# Determination 2022/021

**Regarding the notice to fix issued for the construction of a replacement garage without first obtaining a building consent**

**42 Arran Street, Avondale, Auckland**

**Figure 2: Floor plan of the proposed design (not to scale)**

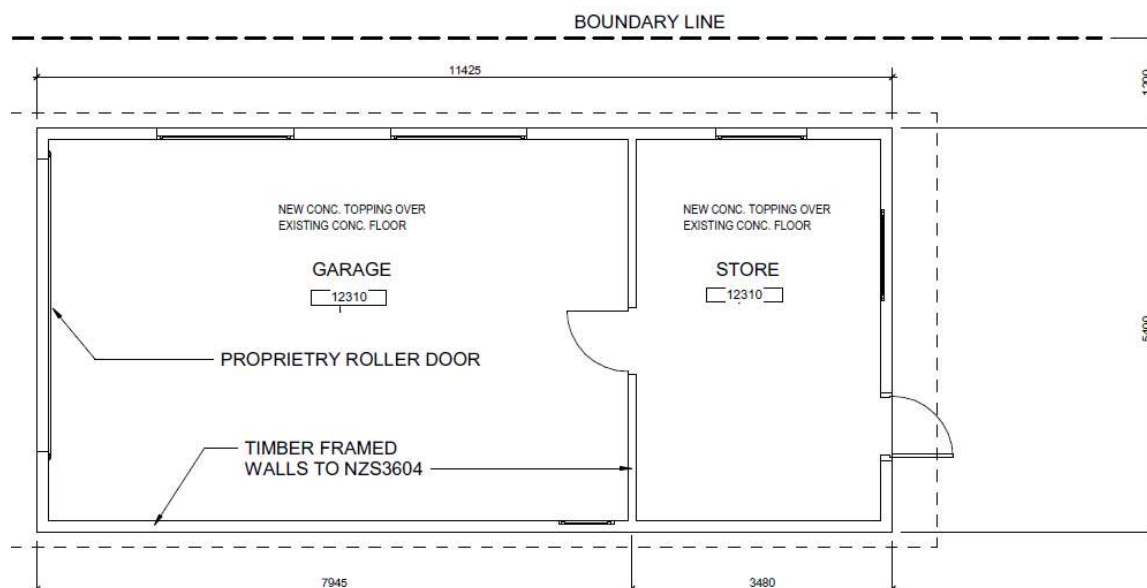
- 2.8. The external wall height of the new garage is 3000mm. This is to allow for a main door of 2750mm high for the owners' vehicle.
- 2.9. The roof pitch has increased from around 20 degrees to 30 degrees, and the height to the apex of the roof is 4550mm.

- 3.8. The authority submits that it believes the work to replace the original garage required a building consent, as it is not “comparable” and therefore failed to meet one of the criteria under Schedule 1, clause 7.
- 3.9. The authority outlines key differences between the original garage and the new garage, namely:
  - 3.9.1. Scale – there is significant increase in height where the new garage walls have gone from 2075mm to 3000mm and the roof apex height is now 4550mm<sup>10</sup>. The roof pitch has also changed

5.11. I reiterate that comparability is looking at the structure as a whole rather than individual components. While I note the increased roof pitch and overall height, I consider that the overall general structure and design of the building remains comparable.

**Figure 3: Drawing of the roof height and pitch (not to scale)**

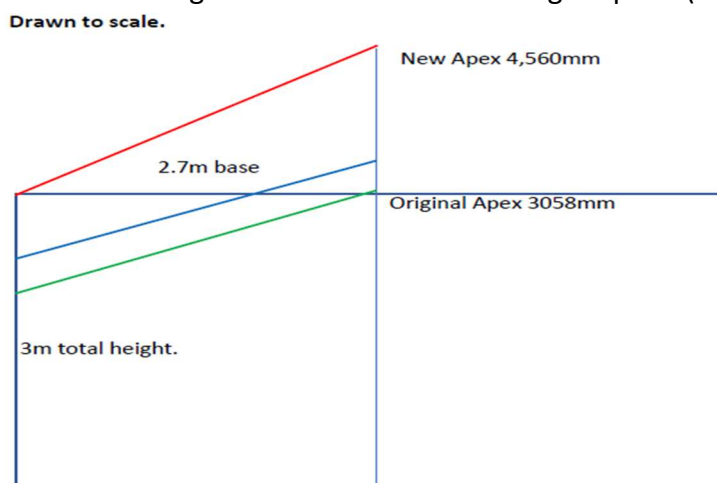
- 3.11. The draft determination was sent to all parties on the 12 April 2022.
- 3.12. The owners accepted the draft on the 22 April 2022 subject to some minor non-contentious amendments, which have been incorporated.
- 3.13. The authority accepted the draft on the 28 April 2022 but added the following comments:
- 3.13.1. The authority accepts that “comparable” is not similar to “like for like”.
- 3.13.2. The authority attached a diagram of the difference in height between the consented sky-line garage with a 20 degree pitched roof and the new garage with 3m high walls and a roof at 30 degree pitch (see Figure 3).

Total width 5,400mm. Therefore base of truss is 2,700mm.

Green line is 2,075mm from ground and at 20°.

Blue line is 2,400mm from ground and 20°.

Red line is 3,000mm from ground and 30°.

Total increase in height is 1502mm.

3.13.3. The authority disagreed with my observation that the height increase is 600mm and stated that the height increase was 1502mm.

3.14.1. they further dispute the authority's assertion that the original apex height was 3058mm, and that the original wall height was 2075mm.

3.14.2. apart from the apex heights, the dimensions in the authority's diagram are not new information in that the authority did not directly challenge the original wall height of 2400mm and therefore hold that the increase in wall height is an "unqualified 600mm".

- 5.9. The total increase in height is a matter of contention between the parties. While the new height is clear at 4550mm (+/- 10mm) neither party can provide evidence to confirm the height of the original garage. Accordingly, I am of the view an increase in height has occurred although it is not clear as to the extent of the difference.
